Craig 9 Ranches Master Drainage Study

CITY OF LAS VEGAS		DATE:
INTER-OFFICE MEMORANDUM		October 27, 2016
TO: Land Development Services Department of Building & Safety		FROM: Albert Sung, P.E. Flood Control Project Engineer Department of Public Works
SUBJECT:	Drainage Study for:	COPIES TO:
	Craig & Rancho Master Drainage Study	Lochsa Engineering
Cross Streets:	SEC of Craig Road & Rancho Drive	Pre Rancho Craig LLC
File Number:	F:\Depot\DSMemos\DS4824B.doc	Bart Anderson, P.E., DevCo
Parcel Number:	138-02-713-002	CCRFCFCD
Zoning Action:	N/A	NDOT
FEMA Flood Zone	YES NO X	
Proposed Storm Drain	YES NO X

**DISTRICT CONCURRENCE: CRAIG & RANCHO MASTER DRAINAGE STUDY
(DS4824B) (RFCD No. 16-9754)**

Subject: Addendum to Craig & Rancho Master Drainage Study
City of Las Vegas DS4824
Lochsa Engineering Project Number: 161051

Inlet Control Nomograph for the Existing/Proposed 18" RCP lateral

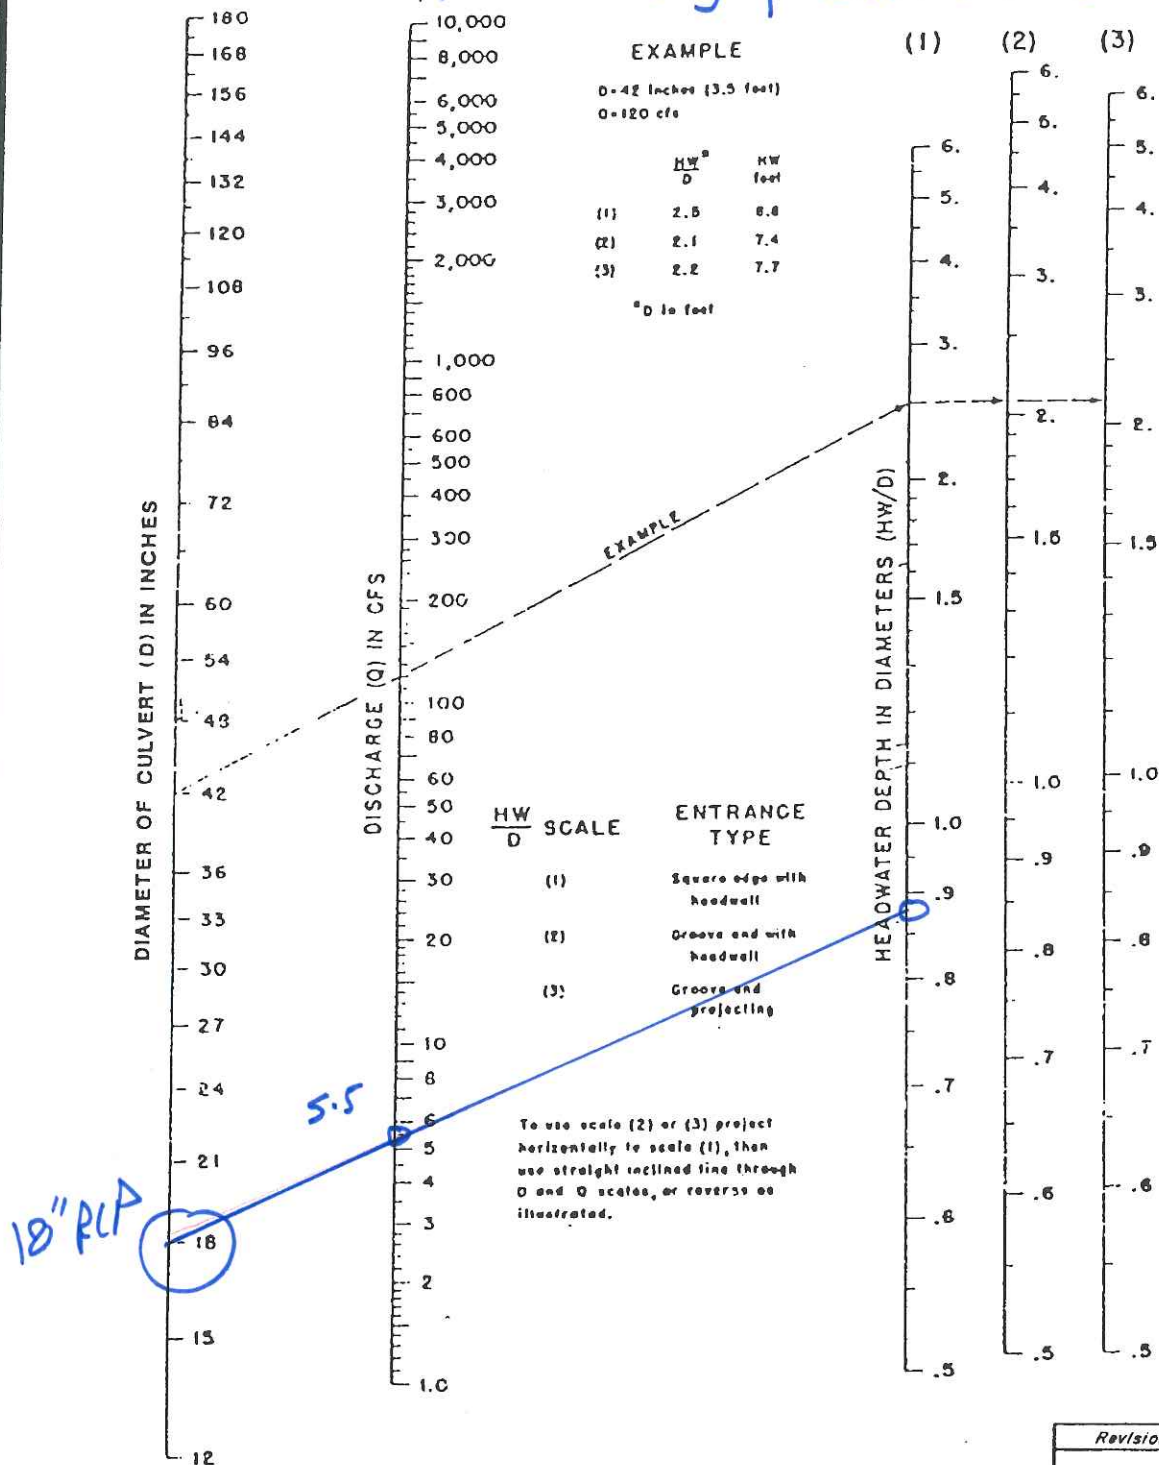
6. **Sheet C2.01:** It appears that the curb return at the intersection of *Craig Road* and *Rancho Drive* is to be re-constructed. However, this was not addressed in the master drainage study. Review and address in the next submittal.

To accommodate the proposed right-turn lane, the existing 4ft Type C drop inlet near Station 111+00 is relocated to the proposed curb. The existing 18" RCP lateral is extended to the proposed drop inlet location. The previously submitted referenced information for Craig Road storm drain is being resubmitted with this Addendum. As shown in the attached referenced information, the drop inlet was labeled as Drop Inlet (D.I.) #11A in the as-built plans for Craig Road. Due to the minor flows intercepted through D.I. #11A, the referenced Craig Road design information did not include hydraulic capacity calculation for the drop inlet. However, utilizing the same referenced design approach and referenced hydraulic parameters (i.e. street flow depth and slope) from D.I. #13 (approximately 400ft downstream D.I. #11A), illustrates approximately 5.50cfs may be intercepted through D.I. #11A. An inlet-control nomograph is provided with this Addendum to illustrate the sufficient capacity of the existing and extended 18"RCP lateral.

Response to Comment No. 7

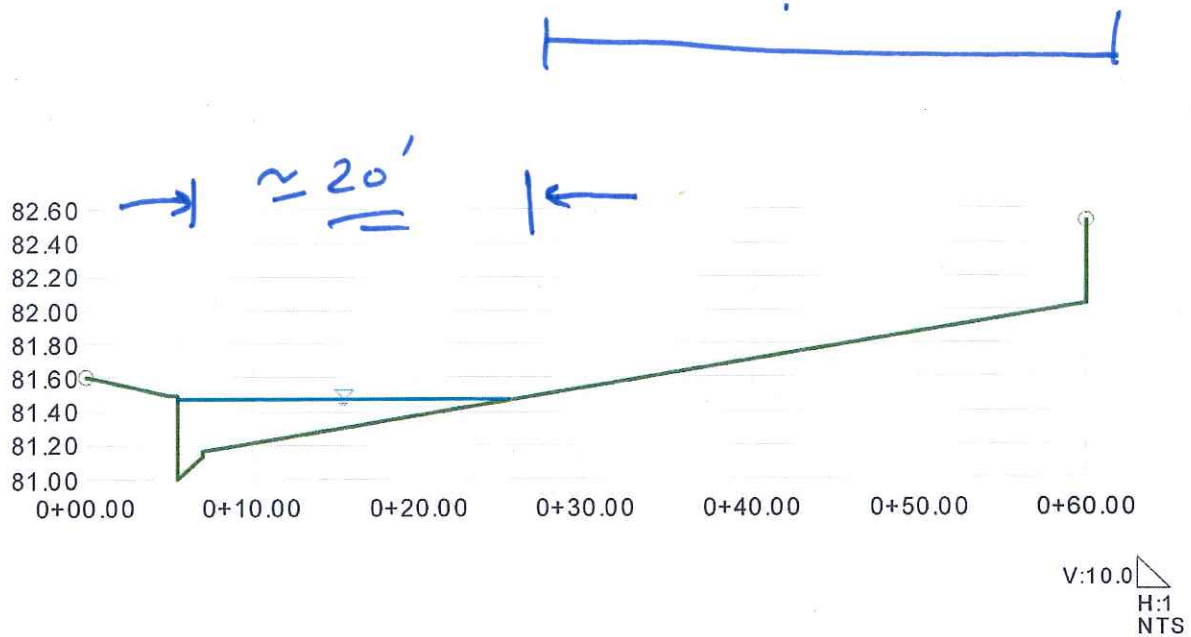
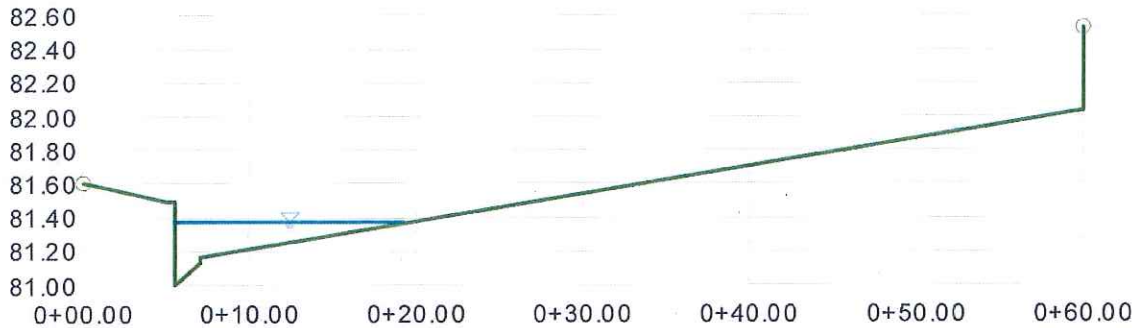
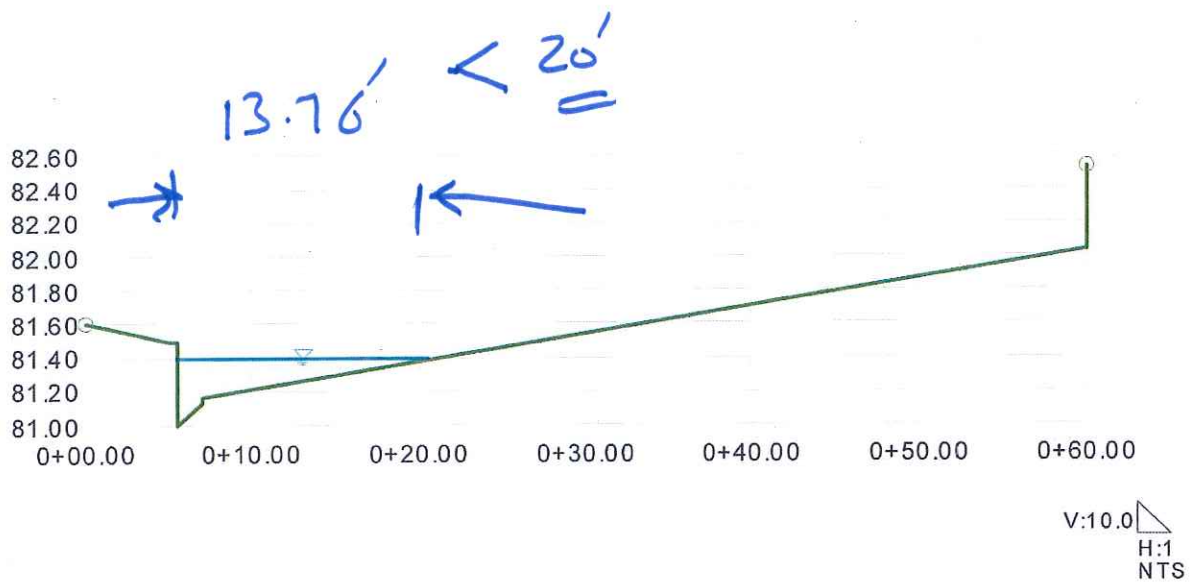
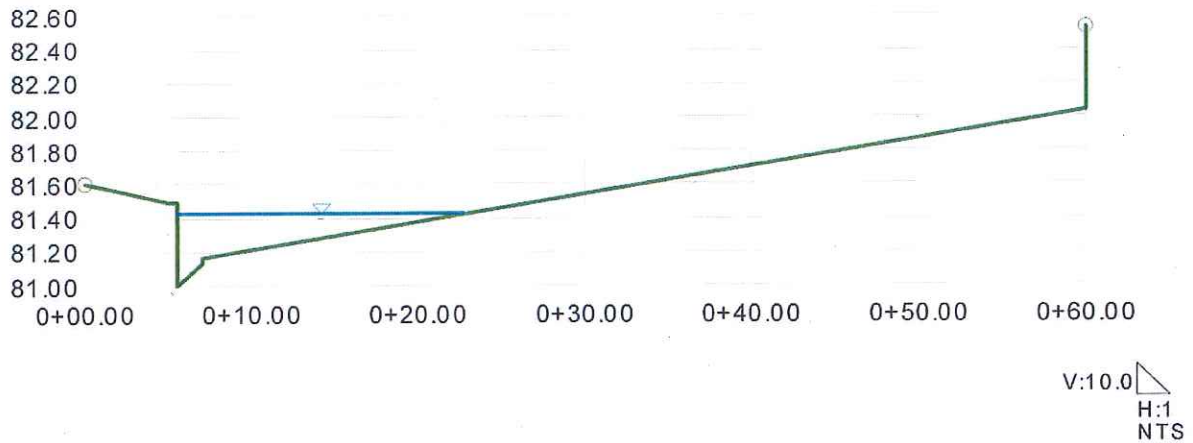
7. **Sheet C2.02:** It also appears that a driveway cut and curb & gutter and sidewalk are proposed in *Rancho Drive*. Review and address in the next submittal.

Response 7: Curb and gutter is being proposed for approximately 500ft of Rancho Drive, up to the proposed driveway entrance. The grading plans for the proposed improvements within Rancho is provided with this Addendum.

Since Rancho Drive is an NDOT right-of-way, it is acknowledged that the proposed curb and gutter represent an obstruction to the flows (from existing condition). Normal depth calculations were previously provided for the east half of Rancho Drive at Sections AA, well downstream of the proposed driveway entrance. The calculations are also being included with this Addendum. The flows near the proposed driveway entrance (i.e. the downstream end of the proposed curb and gutter) are approximately half of the flows at Section AA. Thus, the analysis at Section AA represents a conservative presentation of the flows along the proposed curb and gutter. The 25-year allowable discharge (satisfying the maximum allowable spread) within Rancho Drive near the proposed improvements was determined to be approximately 10cfs. The analysis at Section AA illustrates that the flows are well below the maximum allowable 10-year, 25-year and 100-year flow values. Thus, the flows along the proposed curb and gutter satisfies the NDOT and CLV requirement, and no additional mitigation is required.

Riprap Sizing for the Future Erosion Protection for the 6ft x 3ft RCBCs across
Rancho Drive
(100-year, Existing and Future)

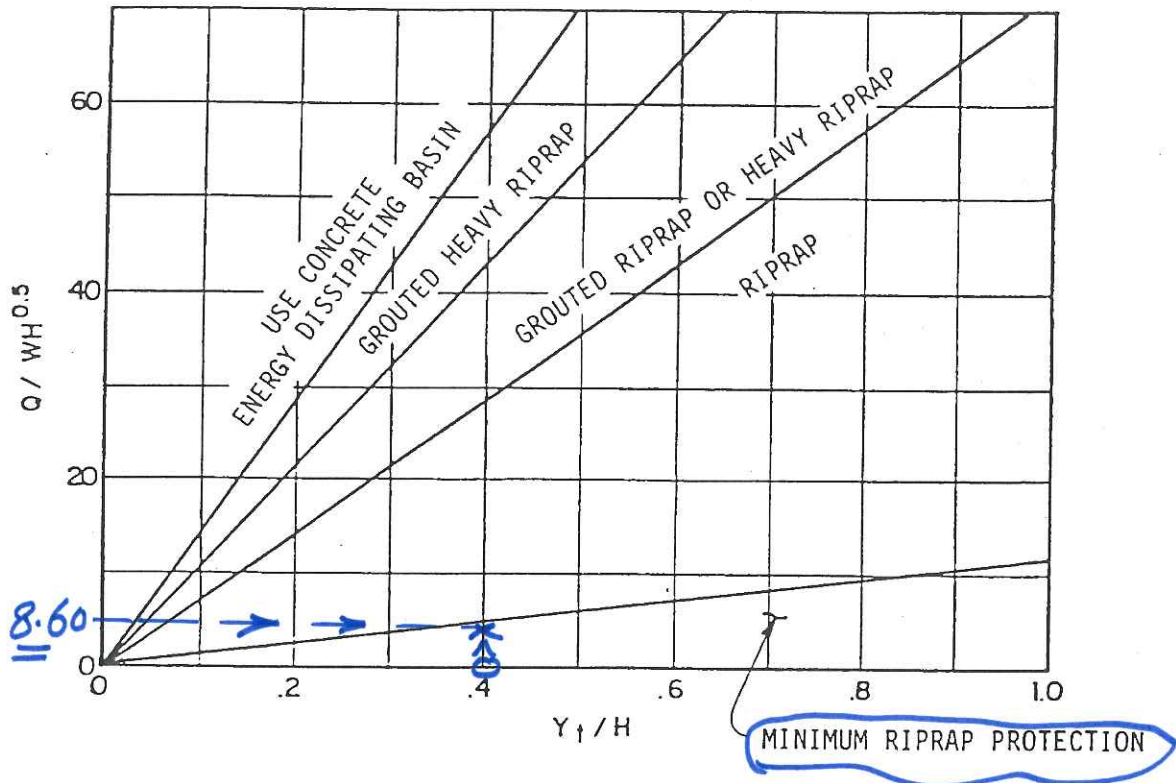
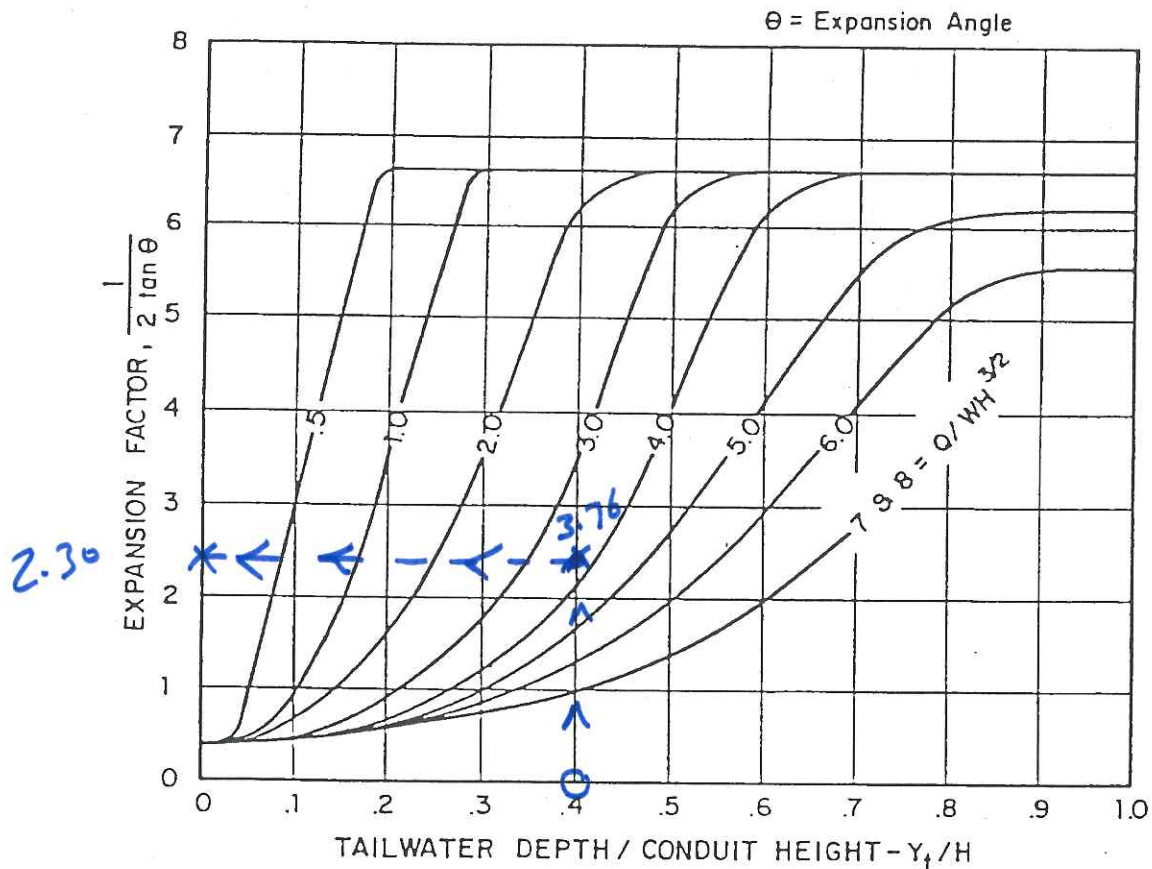
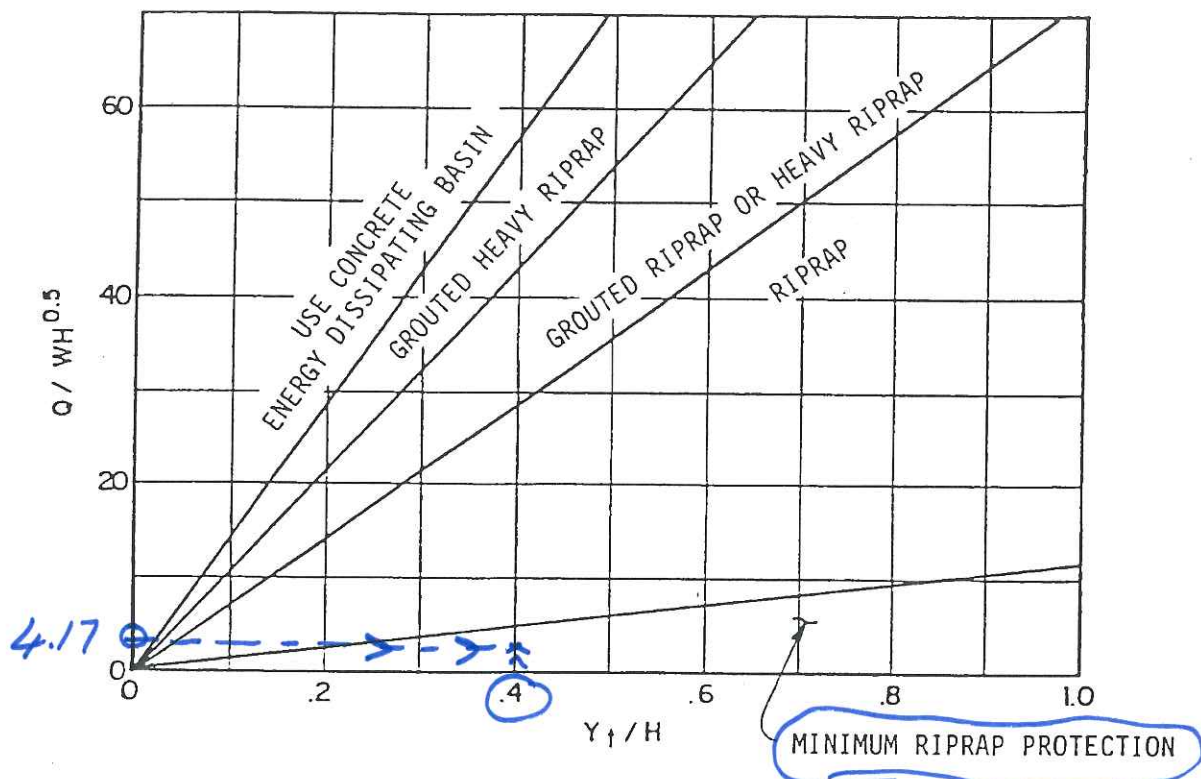
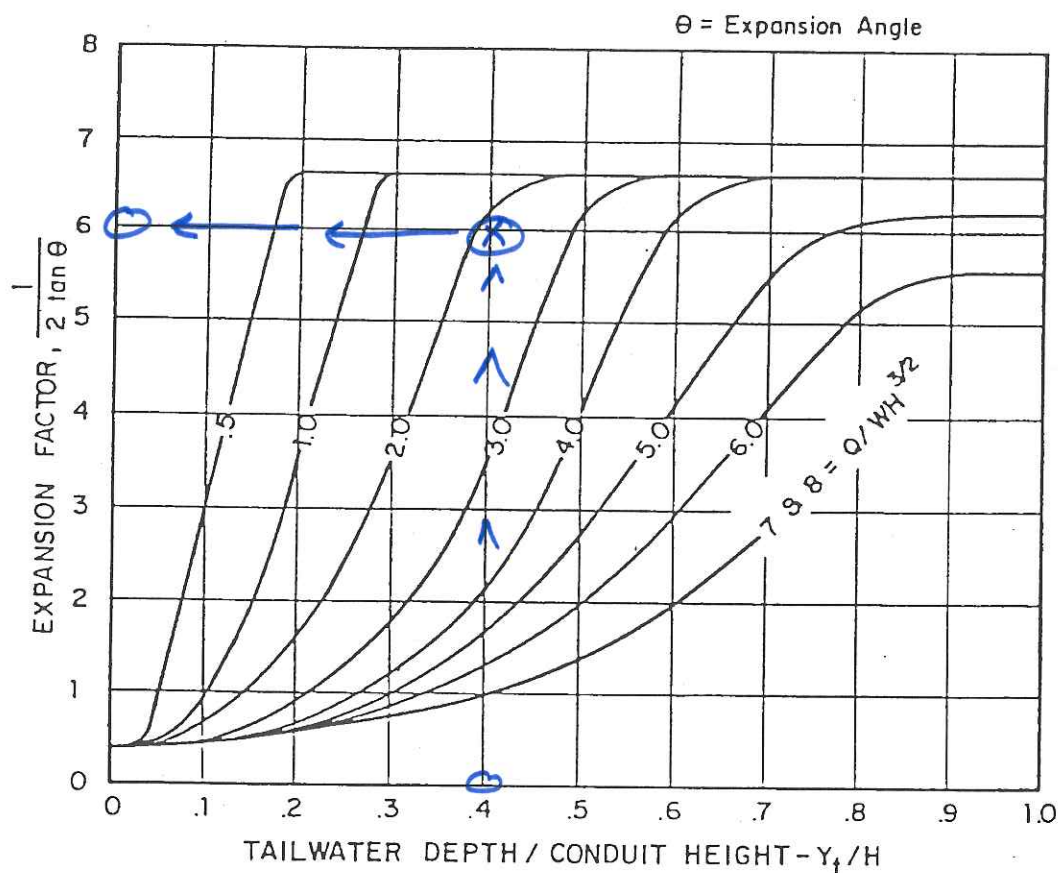
8. **Sheet C2.04 and Sheet C2.06:** Provide erosion control measures downstream of each of the Rancho culverts. Provide hydraulic and sizing of riprap calculations in the next submittal.

Response 8: As confirmed in response to Comments No. 1 and 2, no onsite improvements are being proposed and Sheets C2.01 through C.06 have been eliminated. In addition, the proposed curb and gutter along Rancho Drive ends approximately 850ft to the north of the northern Rancho Drive culverts. Thus, no improvements are being proposed near the existing culverts. Riprap sizing is being provided for the future erosion protection at the outlet of the existing culverts. However, the riprap protection will be proposed with later phases of development of the project site.

As discussed in the previous submittal, 100-year flows for the northern and southern 6'x3' RCB culverts across Rancho Drive are determined to be 78cfs and 35cfs, respectively. Excerpts from the previously submitted information for the existing RCBs are being provided with this Addendum. As shown in the attached erosion protection calculations, minimum riprap protection is required at the outlet of the RCBCs. Minimum riprap sizes of D50=6" may be utilized in the future at the outlet of the existing RCBs.

L = 25.46 <----- However, per Figure 713 (Note 2),
L = 4 x H = 12ft is sufficient for Minimum Riprap

$L = 17.71$ <----- However, per Figure 713 (Note 2),
 $L = 4 \times H = 12\text{ft}$ is sufficient for Minimum Riprap
